Strategic Development Committee

Agenda

Tuesday, 16 July 2024 at 6.30 p.m.
Council Chamber - Town Hall, Whitechapel

On 19 November 2020, Tower Hamlets Strategic Development Committee resolved to raise objections to the GLA in respect of the application. The committee also resolved that in the event of outline planning permission being granted by the Mayor, any future reserved matters applications should be determined by the Committee. In granting hybrid planning permission, the Mayor of London formally resolved that the GLA would continue to be the Local Planning Authority to determine any RMAs. On 18 May 2024, Strategic Development Committee resolved that borough observations shall be reported to committee only when the scale of development would fall within the committee terms of reference. The current RMA would meet the terms of reference for presentation to Strategic Development Committee.

Figure 6: Local Plan Bishopsgate Goods Yard Site Allocation (Site Allocation boundary in red; public square in yellow; strategic pedestrian/ cycling routes in orange; green grid in green)

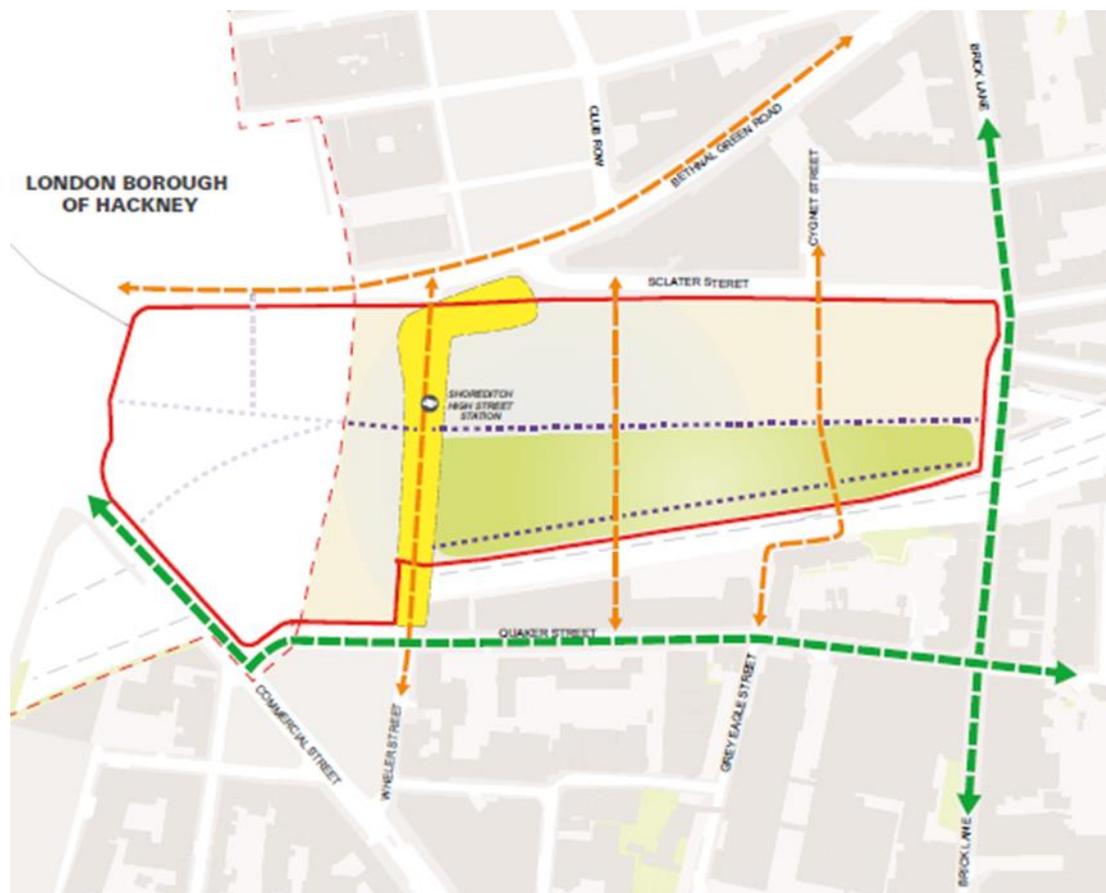
aspirations (shown in figure 6) for a public square and increased public realm at this location. The proposal would be contrary to the Design Guide, as shown in appendix 1.4.

Figure 7: Proposed north elevation (on Bethnal Green Road) with LB Tower Hamlets to left (east) of red line. Blue outline is minimum parameter massing; green outline is maximum parameter massing

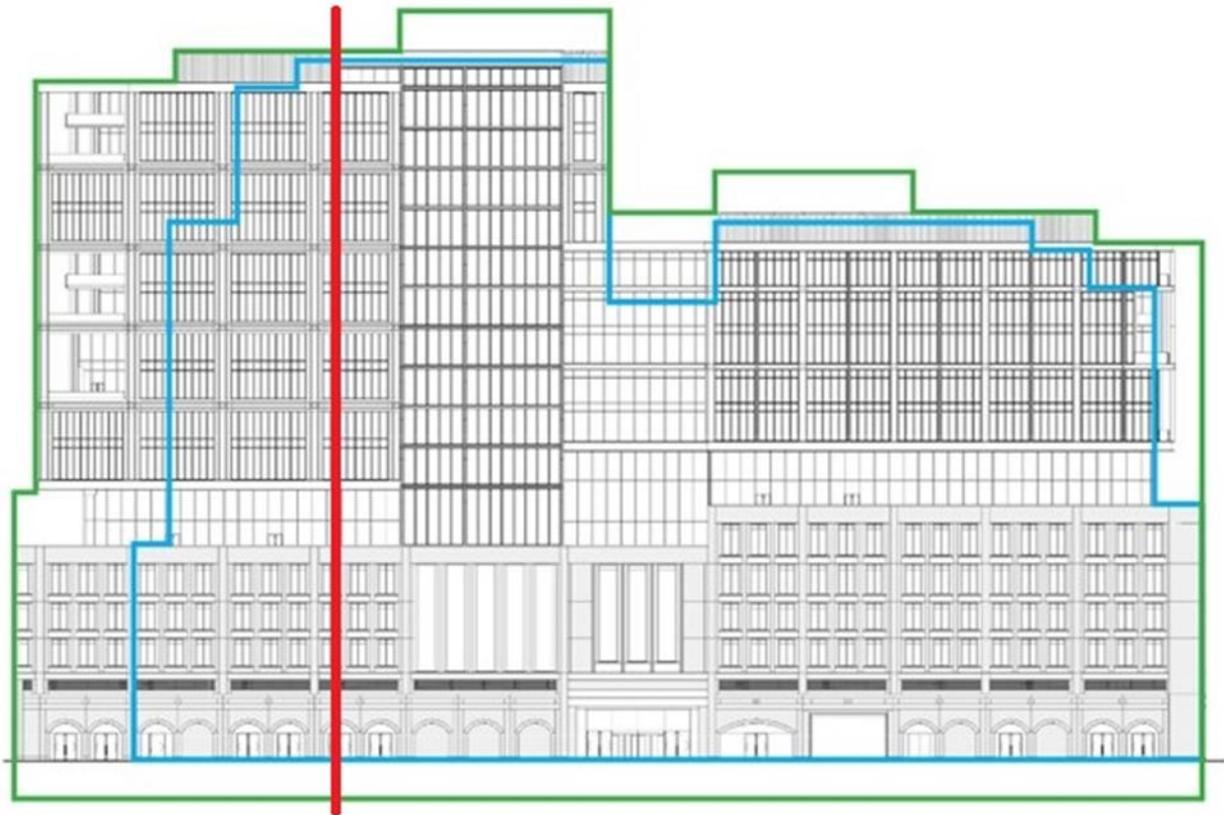
- 7.25 The middle and base of the eastern end of the building (see figure 7 and figure 8) seem unrelated, and a design detail that introduces a familial language would help integrate them and improve the building's cohesion. On the northern (see figure 8) and southern (see appendix 1.3) elevations, the impact of the glazed ribbon detail, a striking transitional feature of the proposals, has been reduced because rather than being recessed (as it is on the western and eastern ends), it is in the same plane as the upper parts of the building.

7.28 Paragraph 4.4.21 of the Design Guide requires that the service access into Plot 1 from Bethnal Green Road will be visually integrated into the proposed architecture – officers are not convinced that it is. In the proposed north elevation (see figure 7), the entrance to the service yard seems out of proportion with adjoining arches, being both higher and wider. It is also extremely utilitarian in appearance. Consideration should be given to introducing an arch to the top of this service yard access. Assuming that gates are required, it should be ensured that these are sufficiently decorative, bespoke and attractive.

Figure 9: Proposed 'Station Square.' 1 is the overhanging gantry; 2 is retail frontage within an enclosed area; 4 is retail frontage to Plot 4; 5 is bollards;

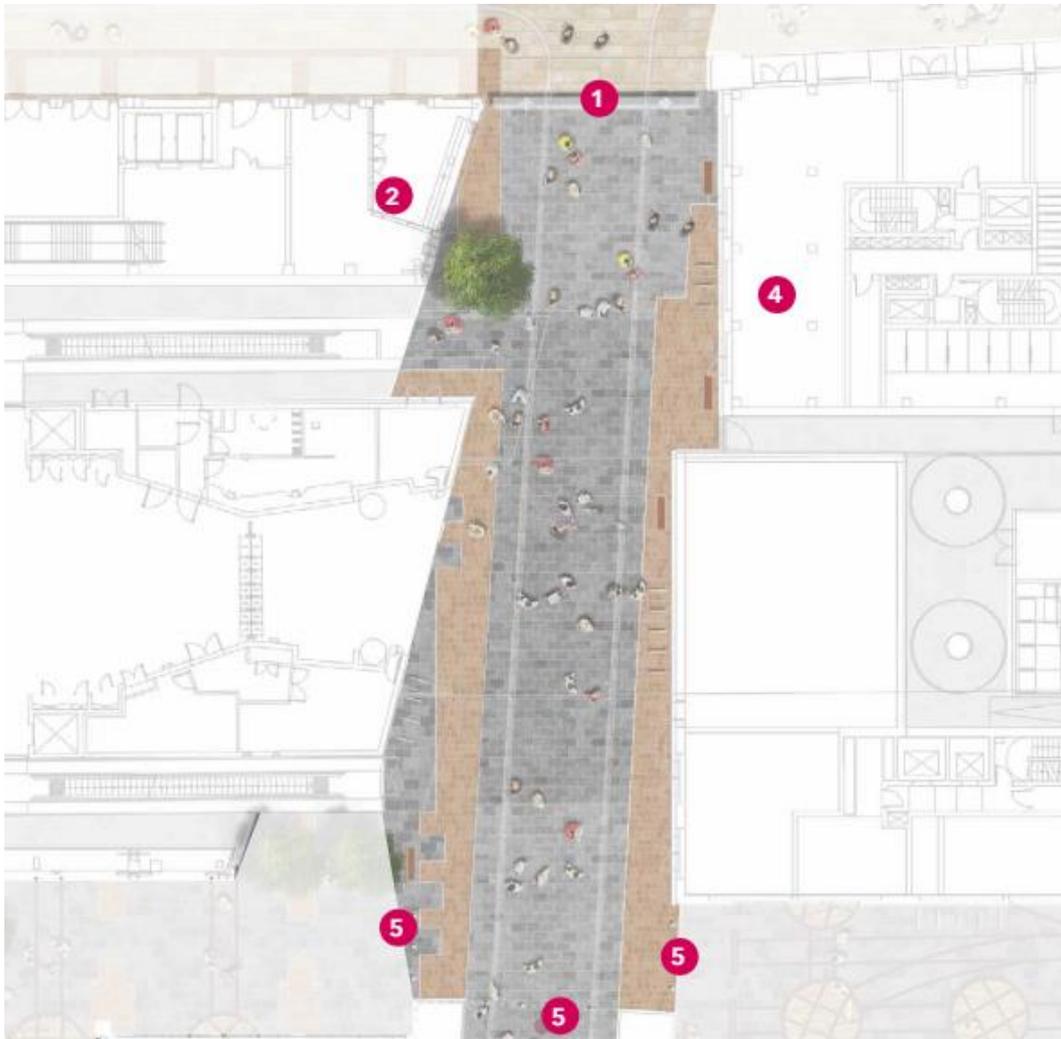
- 7.40 Figure 9 shows the proposed 'Station Square,' within LB Tower Hamlets on Braithwaite Street. Three sets of bollards are proposed around the eastern end of the building on Braithwaite Street – on both sides of Middle Road (the west-east route) and to the south just before the Overground viaduct. It is assumed that these are hostile vehicle mitigation measures – pedestrian desire lines should be considered in the final HVM strategy. Officers would need to see the final HVM strategy at this stage in order to be able to fully assess public realm proposals and ensure minimal clutter along with necessary security measures. If the HVM strategy cannot be provided at this stage then it should be secured by condition.

- 7.42 As shown in figure 7 and figure 9, the proposal involves extending to the maximum parameter of both building footprint and massing. The proposal would not introduce a cantilevered recess. As shown in figure 9, no additional public realm would be provided although it appears that pedestrians could potentially cut through/ past the corner retail unit (marked as number 2) – this would not constitute an adequate colonnade space. It is understood that this space would be shuttered at night to prevent anti-social behaviour – the principle of closing such a space at night is supported, however the space itself is wholly unacceptable. Any cantilevered or colonnade space would require full details of management strategy, process of activation (through elements such as lighting, public art and incorporating retail frontages) and the use of decorative and bespoke detailing to be secured by condition.

- 7.45 Further to above, bollards on Braithwaite Street (shown as number 5 on figure 9) should be minimalised and rationalised. Folding or lowerable bollards should be moved to the northern threshold, underneath where the gantry is shown (number 1), which would create an improved, relaxed pedestrian zone on the approach to Shoreditch High Street station, whilst still allowing emergency vehicle access.

Figure 11: Image showing surrounding land uses (residential in pink)

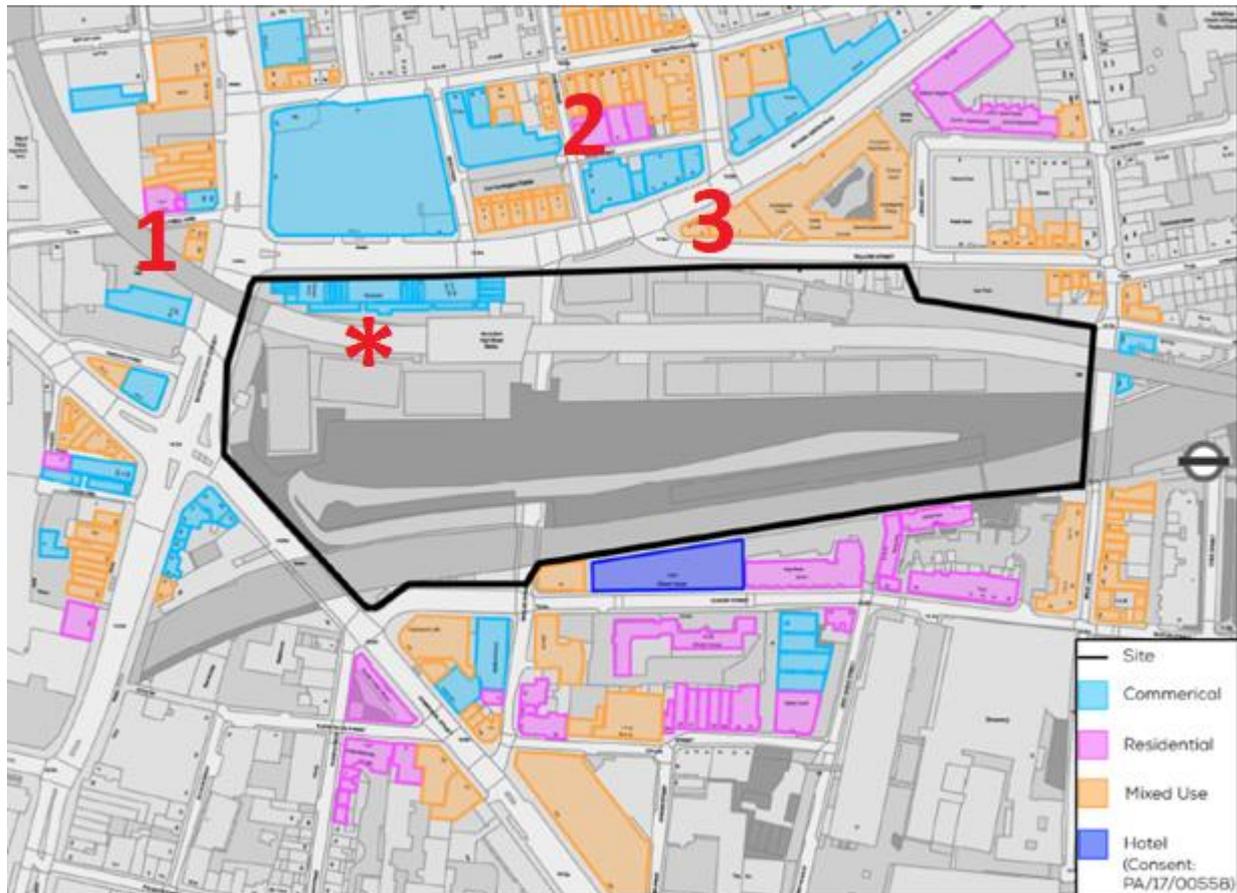
- 7.59 As mentioned above, the nearest residential units to Plot 1 appear to be those shown on figure 11. Major adverse impacts to daylight and sunlight were attributed to these existing homes. For 28-30 Bethnal Green Road, it would appear that impacts would mainly arise from the interaction with Plot 4 and Plot 5 rather than Plot 1 which is further away. For 2-4 Chance Street, it was factored in that this second floor property had low existing levels and was self-restricted by its

overhanging roof. For properties on Shoreditch High Street, the retained levels were found to be appropriate even though the losses were significant.
